# ENGINEERING CHANGE NOTICE

Date: 12.11.16	Job No.: ENG 3106	ADR Yes/No: N	ADR Date: <del>12.11.16</del>	ECN #: 12- 678
Product No.: D412-706	Created By: RF	Approved By: <del>RF</del>		
Product Name: Fuel Purge Canister Installation	Checked By: <del>RF</del>

Reason for Change:	Revise documentation per PAR12-184
--------------------	------------------------------------

Documents Affected:	IIN-D412-706 Rev. B ICA-D412-706 Rev. 1 MDL-D412-706 Rev. A
---------------------	---

## 5. PARTS LIST

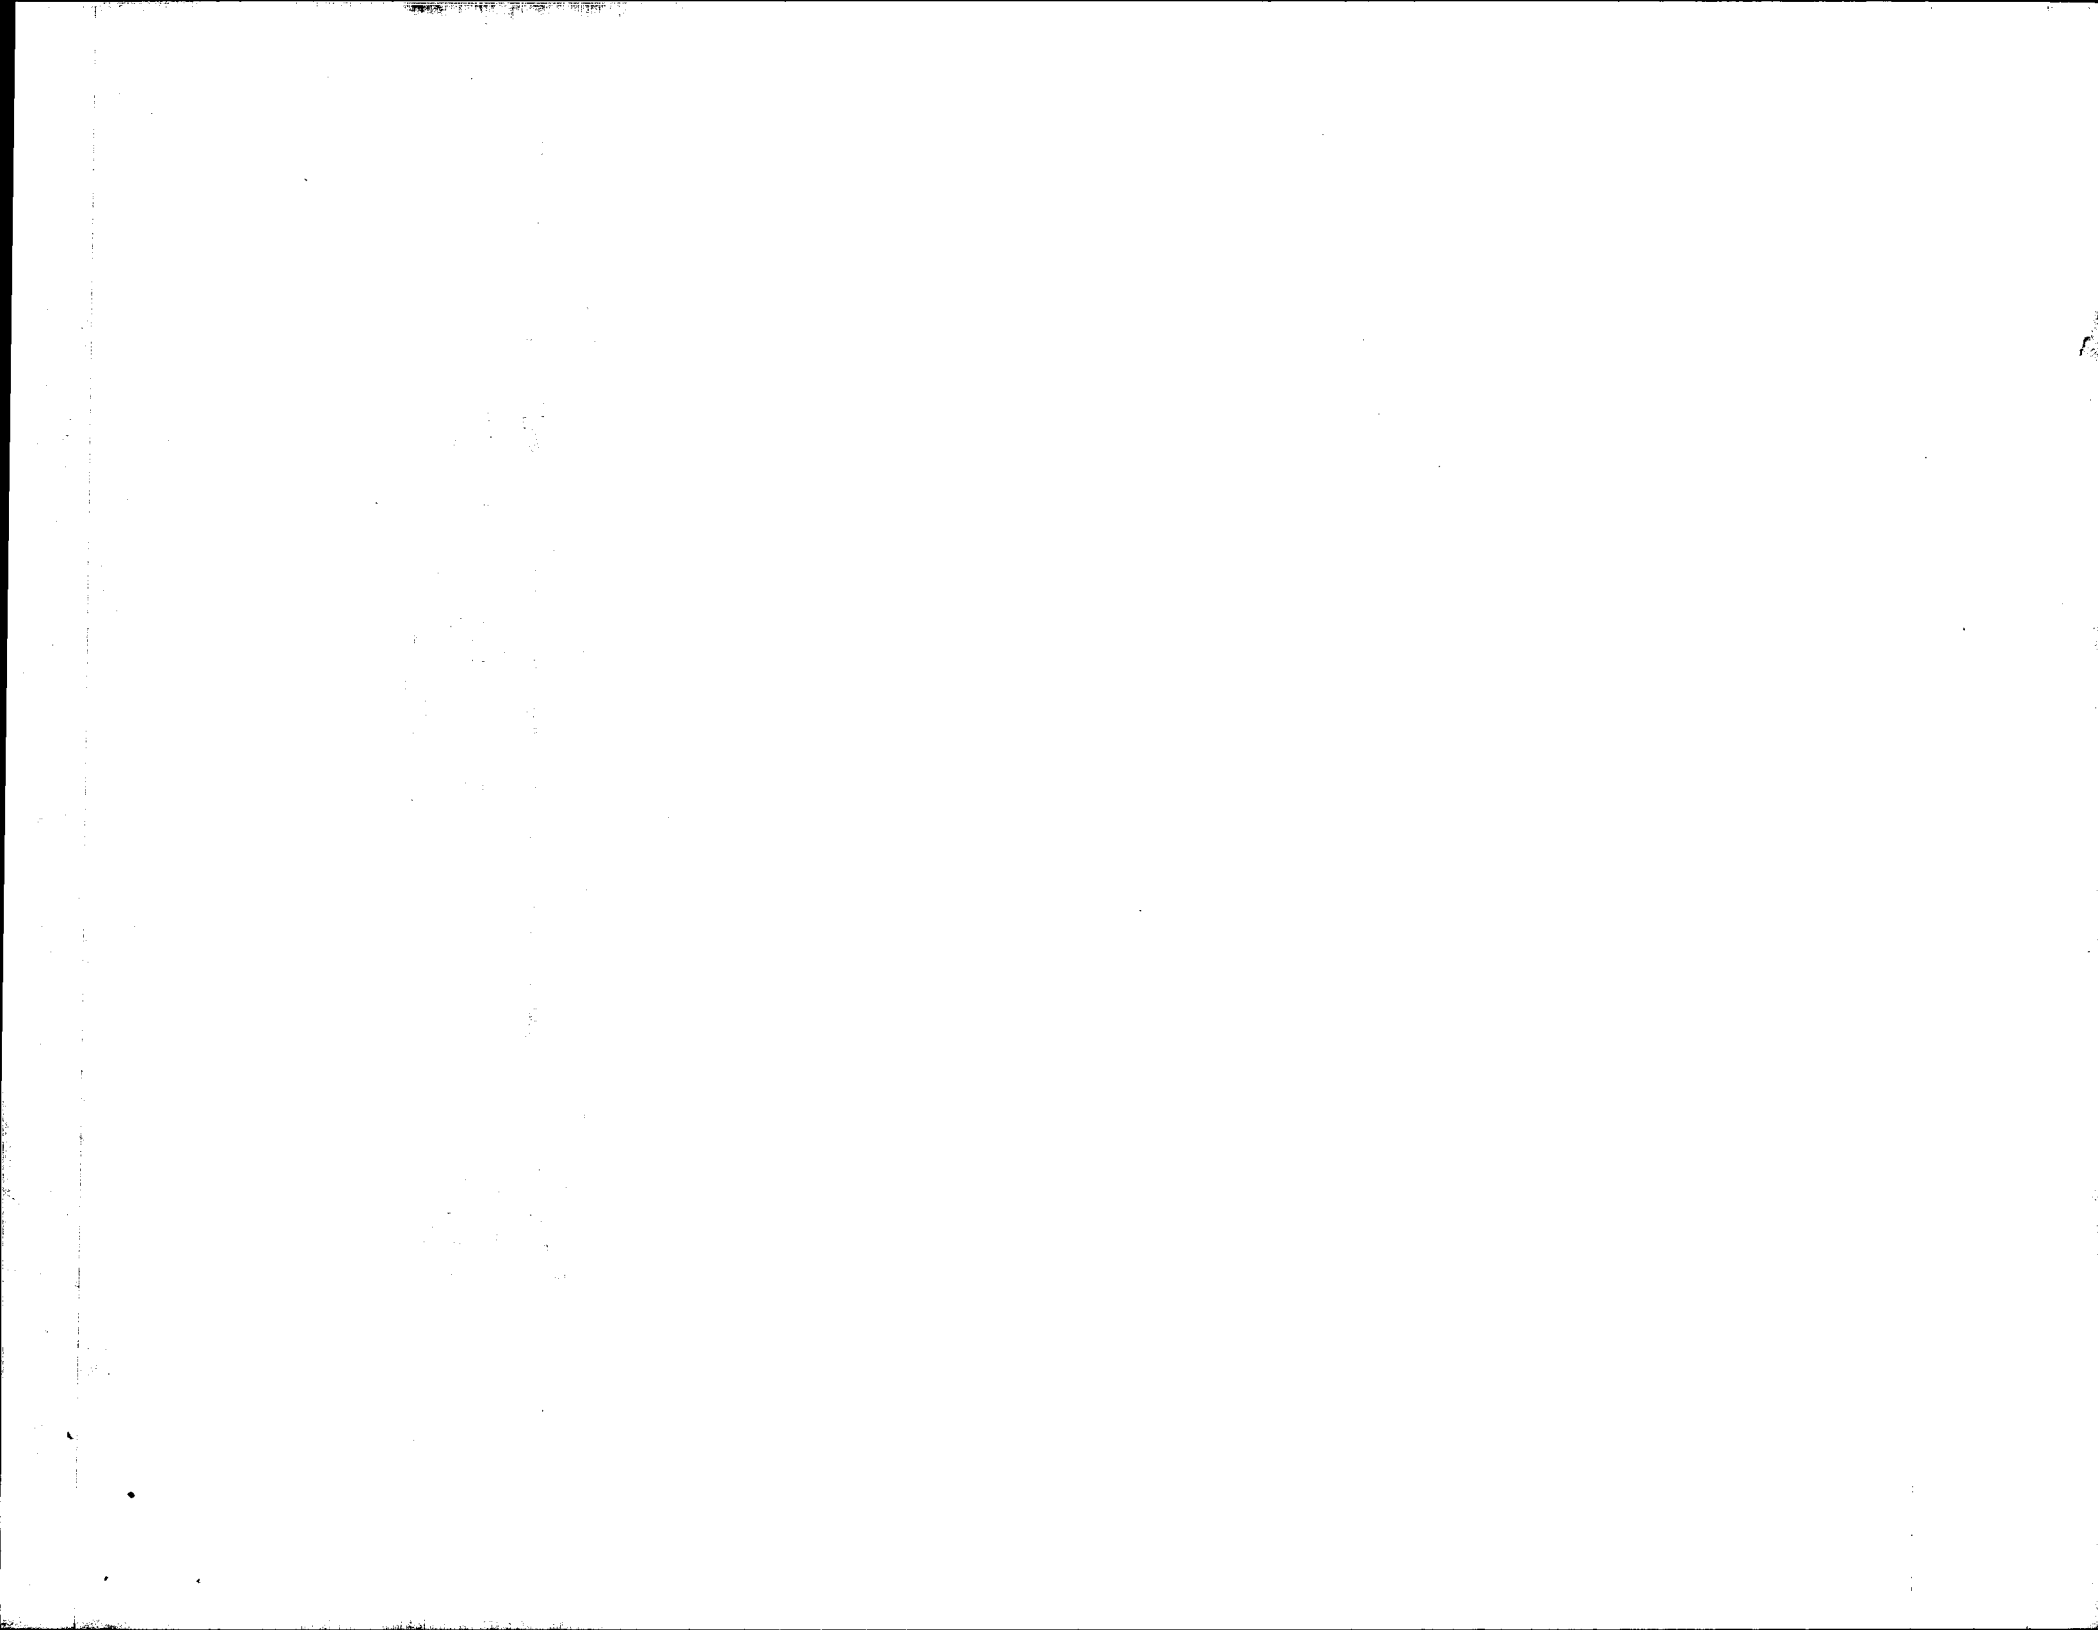
Description / Action:	Update BOM/routing FOR -011/-013/-015 per IIN-D412-706 Rev. B D412-706-011 @ CHG 004; D205-706-013 @ CHG 003 Ensure -011/-013 kits in stock/in progress are updated per part list from IIN-D412-706 Rev. B  <div style="font-family: cursive; font-size: 1.2em;">             1 sth 92677 rework 94320              1 mp 93258           </div>
-----------------------	---

[10:00:50 AM] Linda Lacelle: i'm looking through the curent bom and the new IIN, and for the 205 kit, i think we have to change the MS28778-6 for a MS29512-06, is this correct>?

[10:01:44 AM] Linda Lacelle: and for the 412 kit, i have to remove the D3297-3-085, and replace it with a D3297-1-0121 and remove completely the AN832-6D, is this correct?

[10:05:06 AM] Roberto Fuentes: Yes, Oring is change, you are correct, it is required to update the kit per the new part list, ane replace the hose line and the fitting according.
